Landscape Referral Response

Application Number:	Mod2024/0473
Date:	12/09/2024
Proposed Development:	Modification of Development Consent DA2020/0393 granted for demolition works and construction of a shop top housing development comprising retail premises, 49 dwellings, basement carparking and landscaping
Responsible Officer:	Kye Miles
Land to be developed (Address):	Lot 1 DP 1199795 , 28 Lockwood Avenue BELROSE NSW 2085

Fig.1 Comparison of the approved scheme entry off Glenrose Place (left) and the proposed scheme (right).

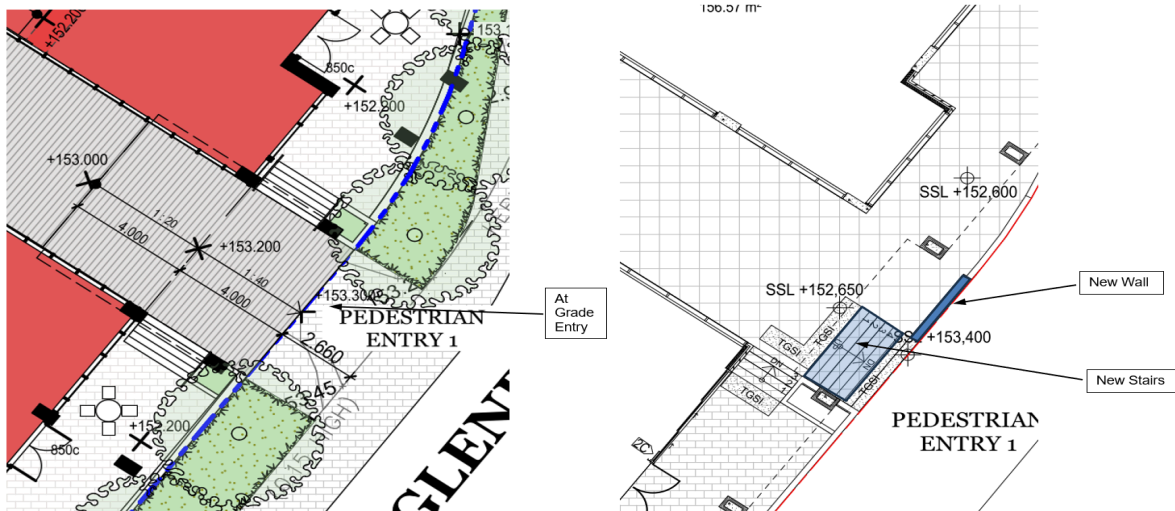
The approved plans provide a wide, at grade pedestrian entrance form Glenrose Place. This provided an inviting entrance to the courtyard area in terms of visual connection and ease of access between the site and the Glenrose Shopping Centre.

The proposed plans alter the level of entry. The entrance to the courtyard area is now indicated to incorporate stairs and a wall at this important entry point, which is considered to be a poorer design outcome to the approved plans as the link between the site and Glenrose Shopping Centre is diminished. (Fig.1)

Fig.2 Comparison of the approved courtyard scheme (left) and the proposed scheme (right).

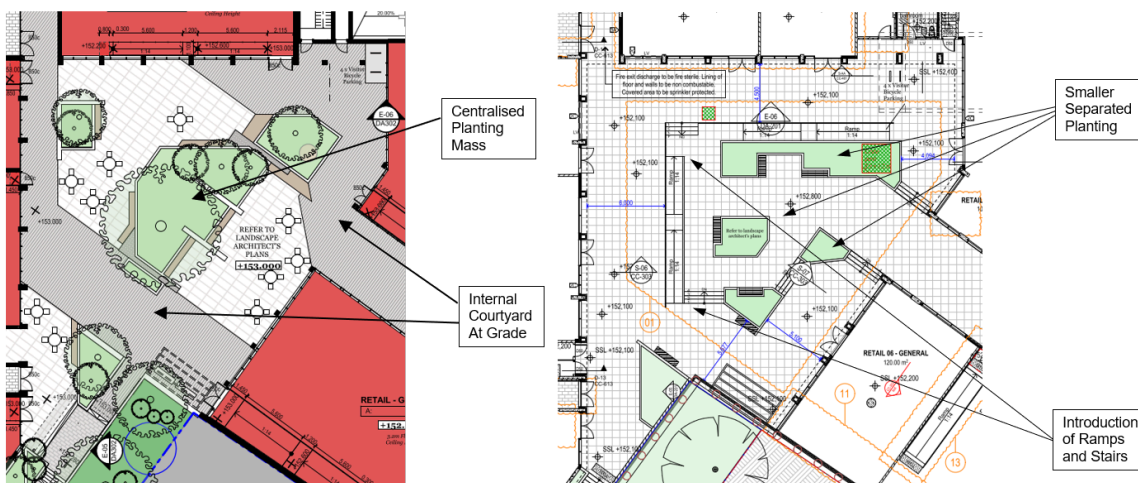
The approved plans are based on a level area across the courtyard, flowing between retail outlets, seating and pedestrian space. The internal courtyard now includes a series of ramps and stairs to between the main passive component of the courtyard and the retail space access and unit access ways. The stairs and ramps alter the spaces previously provided and affect the permeability of the courtyard space.

The approved plans accommodate centralised planters providing adequate soil volume to support the approved planting scheme of trees, palms, shrubs and ground-covers. The modification requires the planters to be separated into narrower, smaller units which are unlikely to support the planting scheme as previously approved. (Fig.2).
